UNITED STATES PATENT AND TRADEMARK OFFICE

APPLICATION NO.	FILING DATE	FIRST NAMED INVENTOR	ATTORNEY DOCKET NO.	CONFIRMATION NO.
10/605,234	09/17/2003	Chih-Han Chang	NTCP0004USA	3393
27765	7590	04/27/2005	EXAMINER	
NORTH AMERICA INTERNATIONAL PATENT OFFICE (NAIPC)			NGUYEN, KHIEM D	
P.O. BOX 506			ART UNIT	PAPER NUMBER
MERRIFIELD, VA 22116			2823

Office Action Summary	Application No. 10/605,234	Applicant(s) CHANG ET AL.	
	Examiner Khiem D. Nguyen	Art Unit 2823

DETAILED ACTION***Continued Examination Under 37 CFR 1.114***

Fig. 6

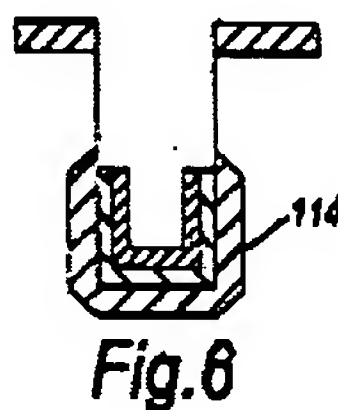
depositing a silicon nitride layer on the inner wall of the deep trench after removing the remaining sacrificial layer; performing a thermal process for forming a doped region **114** at a bottom of the trench (col. 2, lines 54-61 and FIG. 6);

Fig. 7

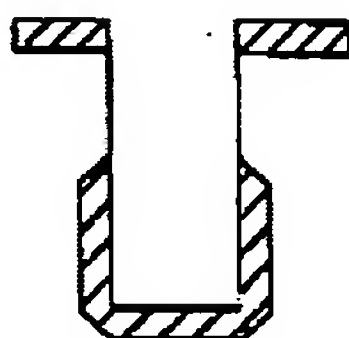
removing the silicon nitride layer; and removing the doped silicate glass film (col. 2, lines 62-64 and FIG. 7);

AMENDMENTS TO DRAWING FIGURES

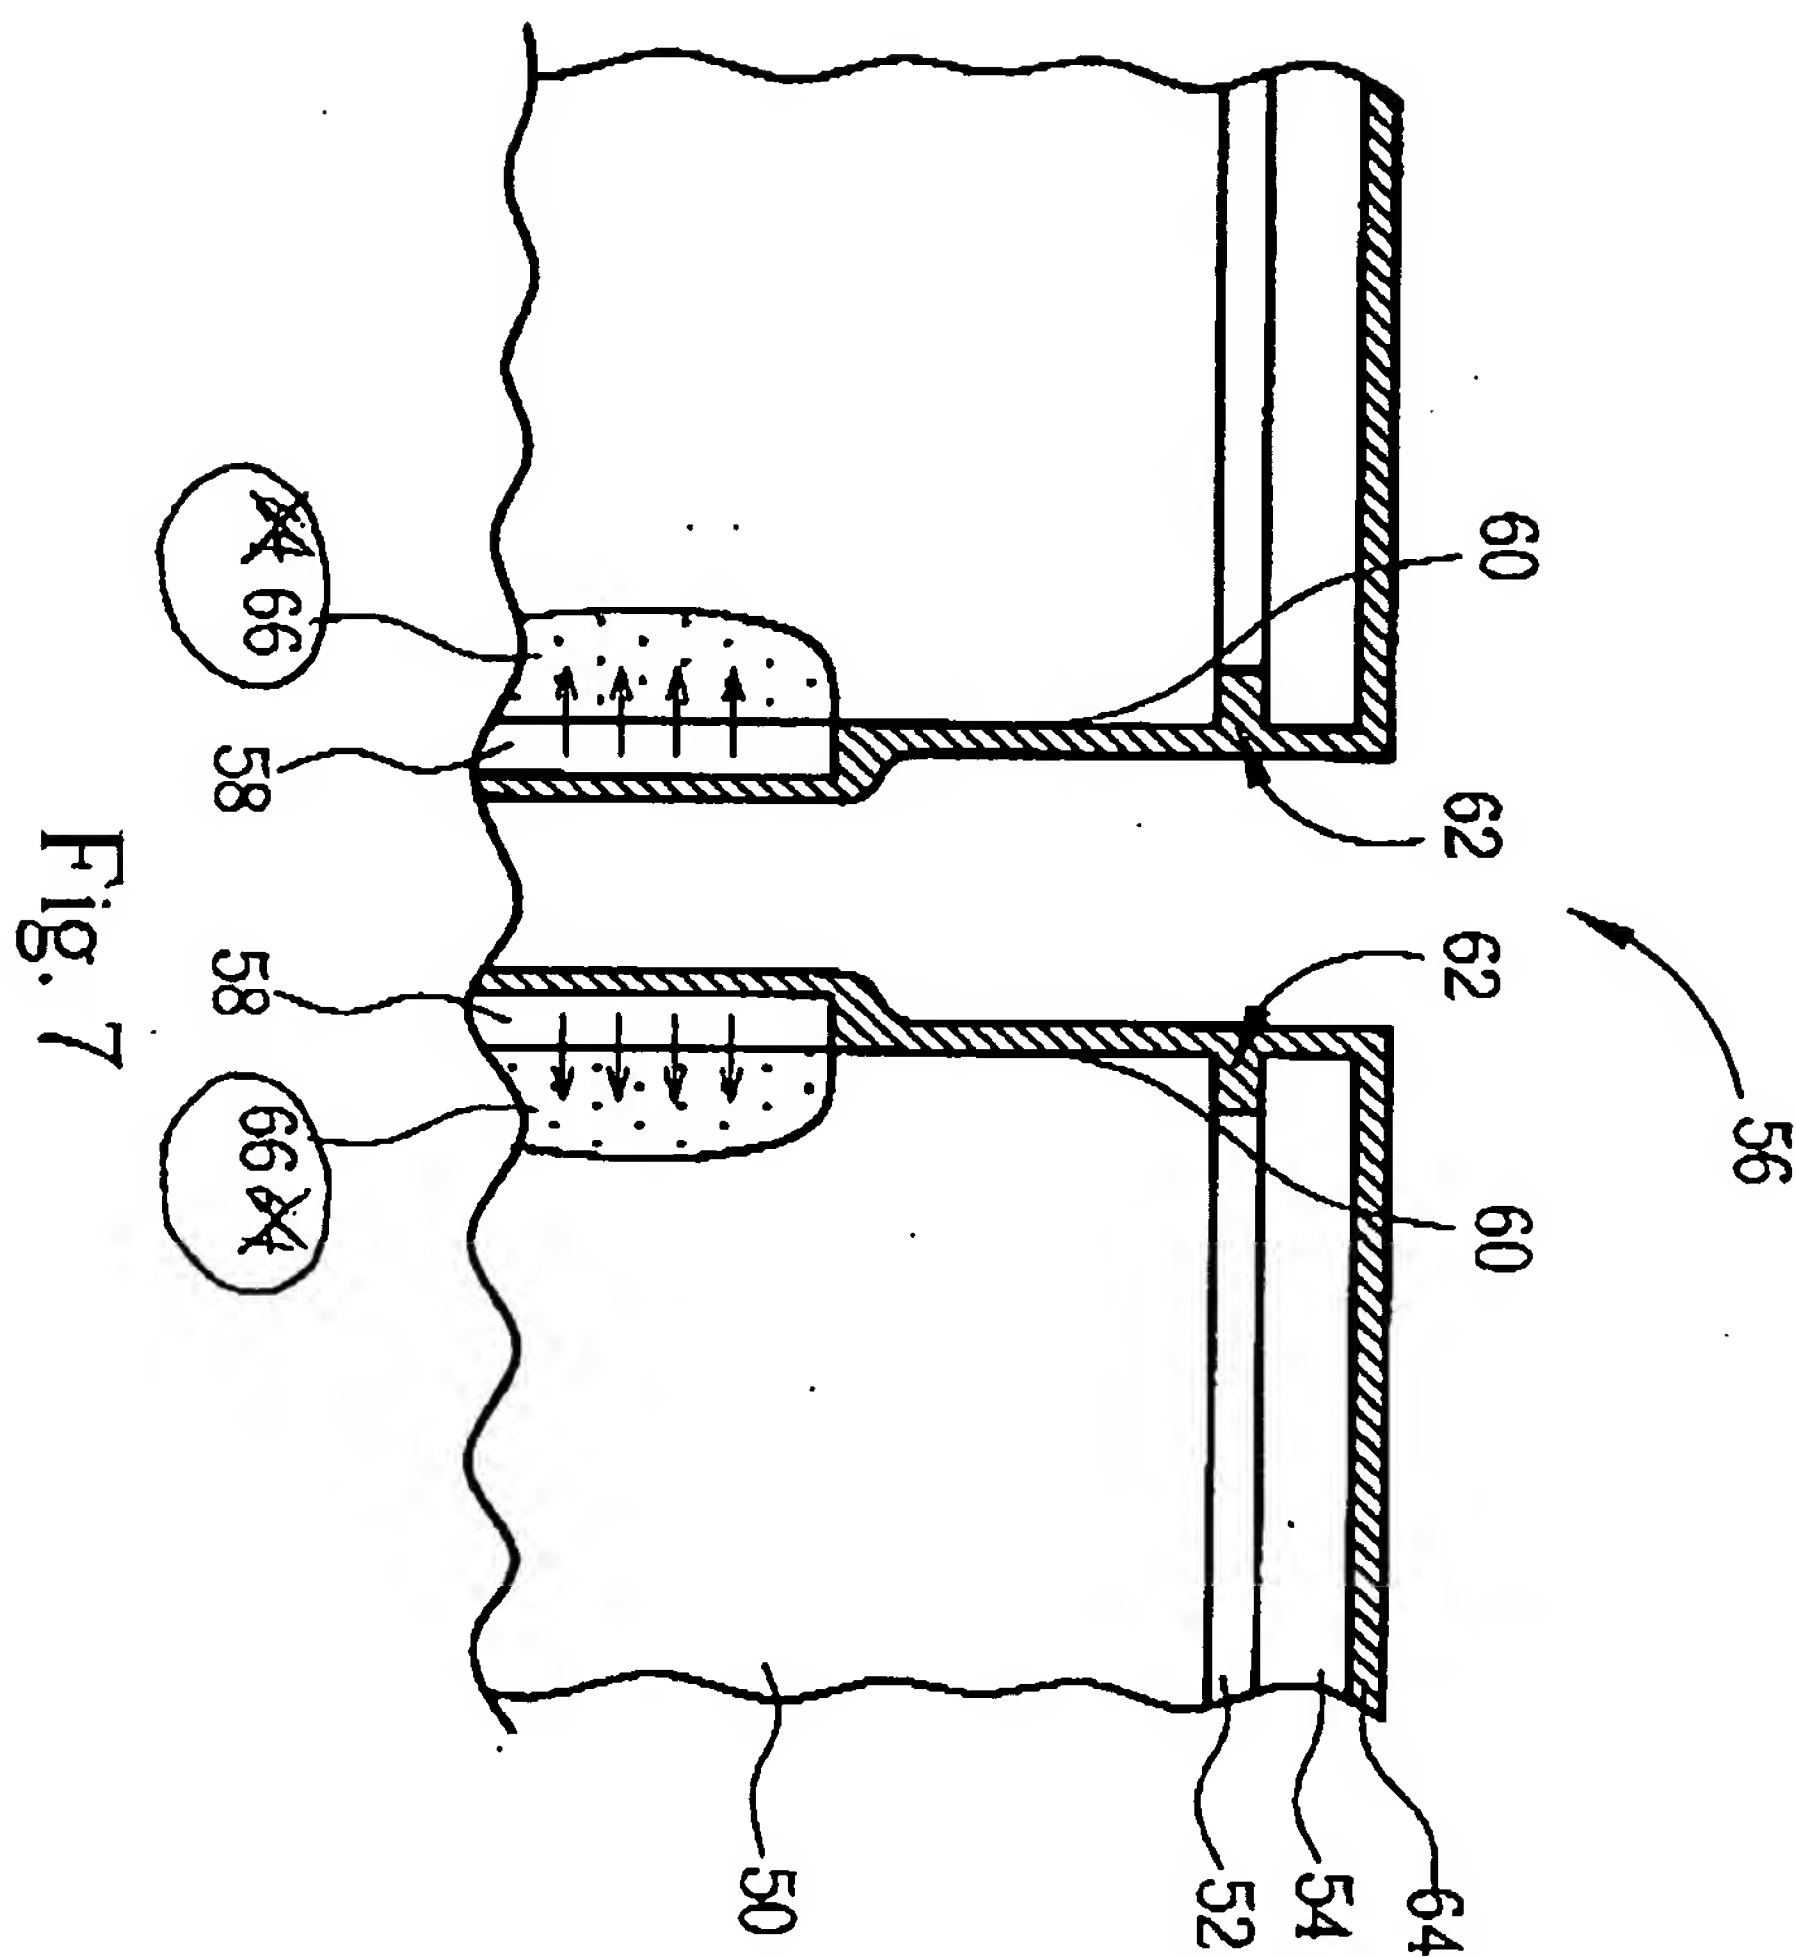
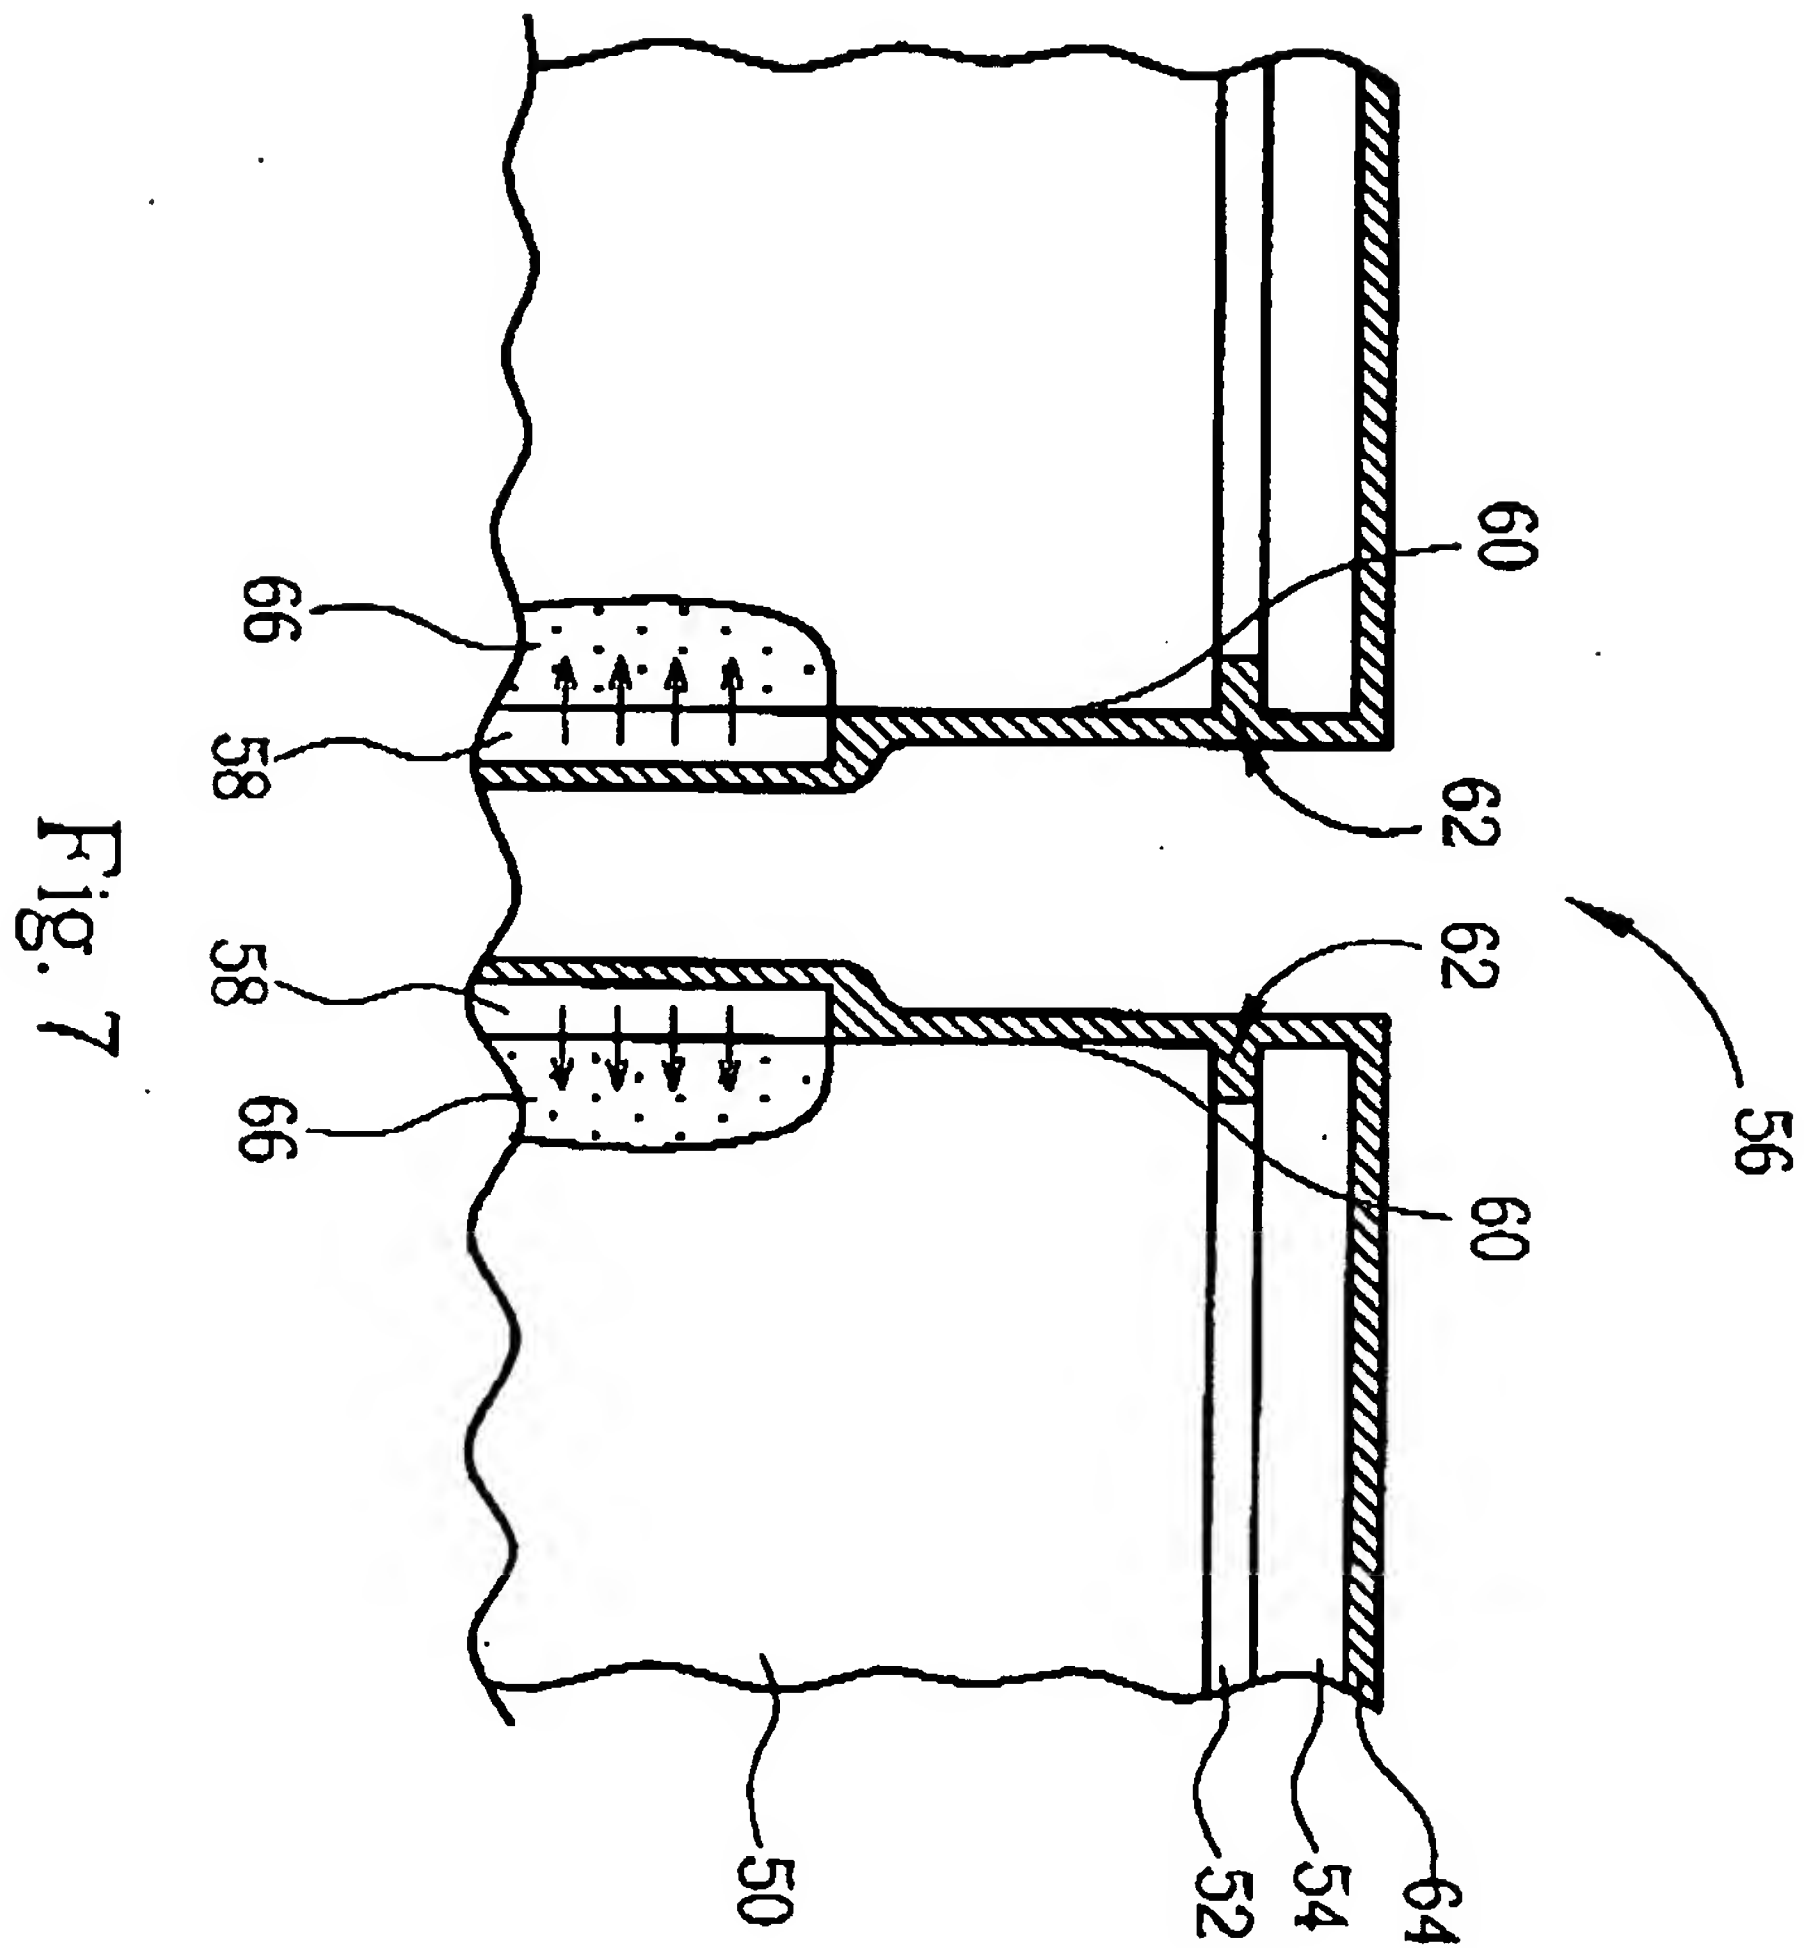
Figs.7 and 8 have been redrawn to change the numerals "64" of the doped region to "66" as shown in the encircled area of the attached "Annotated sheet". The applicant had mistakenly used the numeral "64" to refer to two different elements, and this error has been corrected. No new matter is introduced by the above amendments. Consideration of the proposed amendment to the drawings is politely requested.

Approved
